DEVELOPMENT APPLICATION ASSESSMENT REPORT

Application Number:	DA2025/0563
----------------------------	-------------

Responsible Officer:	Olivia Ramage
Land to be developed (Address):	Lot 10 DP 17704, 26 Cabarita Road AVALON BEACH NSW 2107
Proposed Development:	Alterations and additions to a dwelling house
Zoning:	C4 Environmental Living
Development Permissible:	Yes
Existing Use Rights:	No
Consent Authority:	Northern Beaches Council
Land and Environment Court Action:	No
Applicant:	Natasha Cook

Figure 1 - North elevation showing envelope breach in red

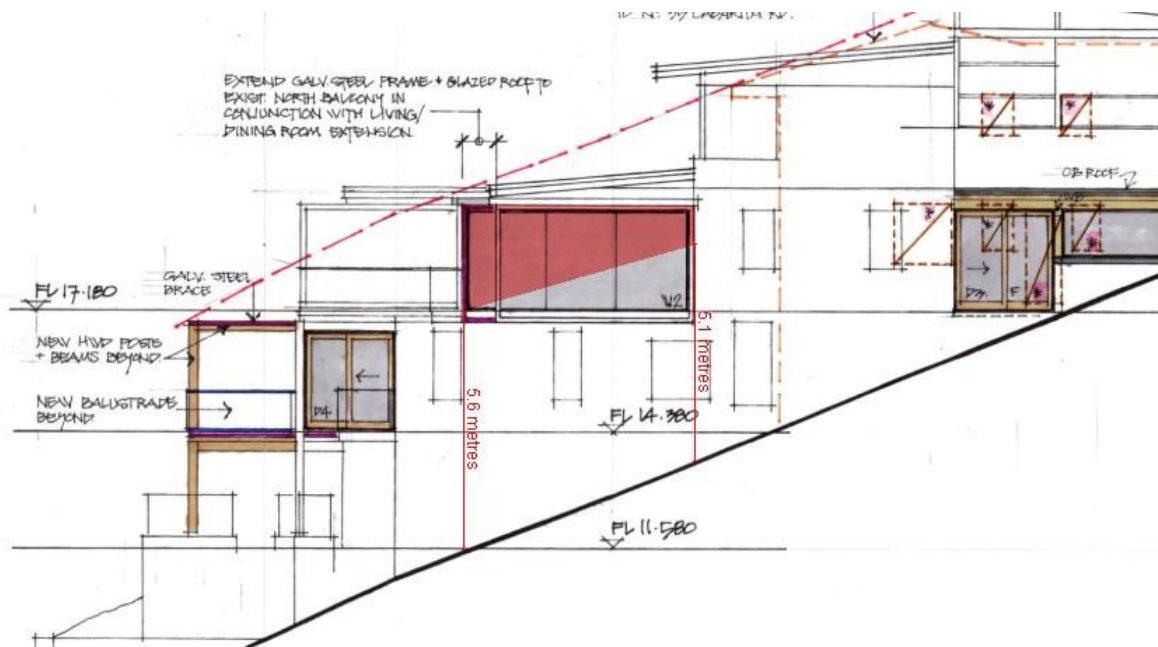
The proposed development encroaches both the northern and southern side building envelopes as shown below.

The proposal maintains the existing building footprint with the level 2 balcony sited over the existing terrace and the level 3 addition involves enclosing the existing roofed balcony. As such, the breach on the northern elevation is limited to the new glazed windows to enclose the

Figure 2 - South elevation showing envelope breach in red

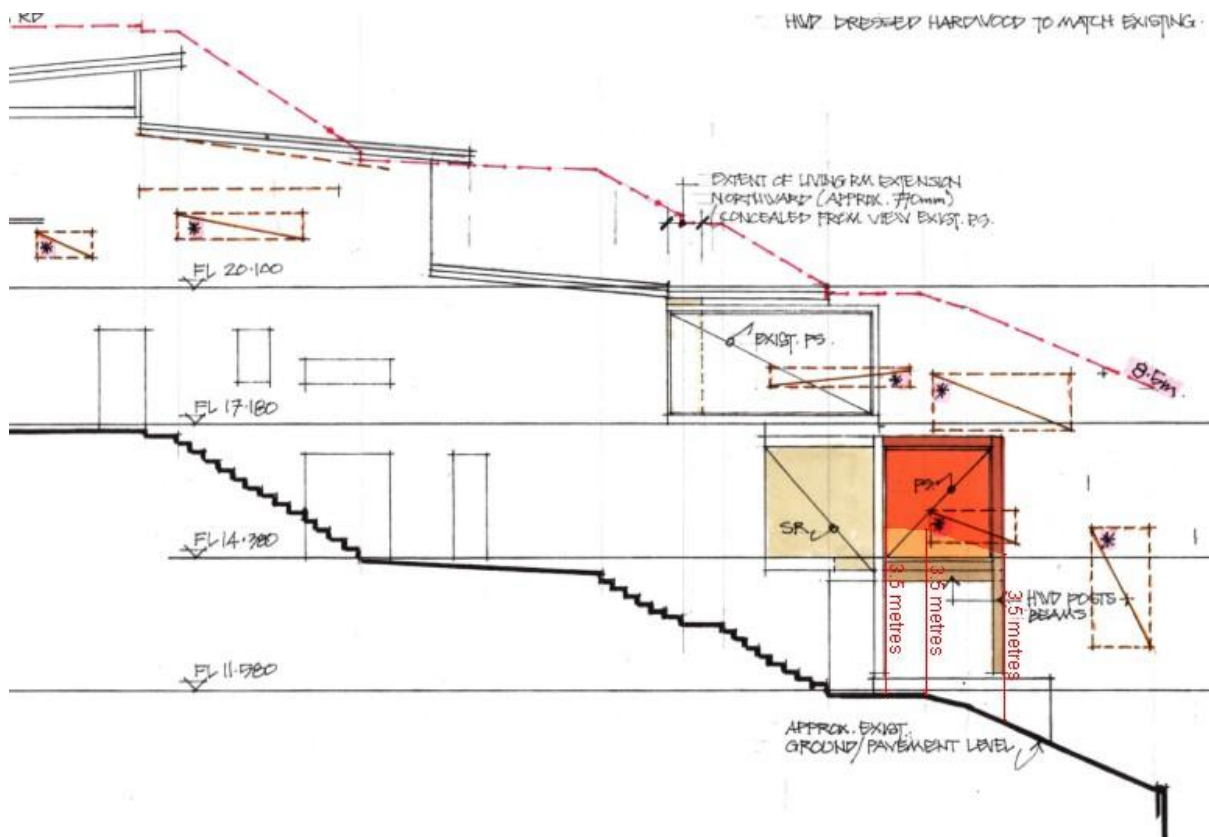
balcony. The breach on the southern elevation is limited to the privacy screen to the new balcony.
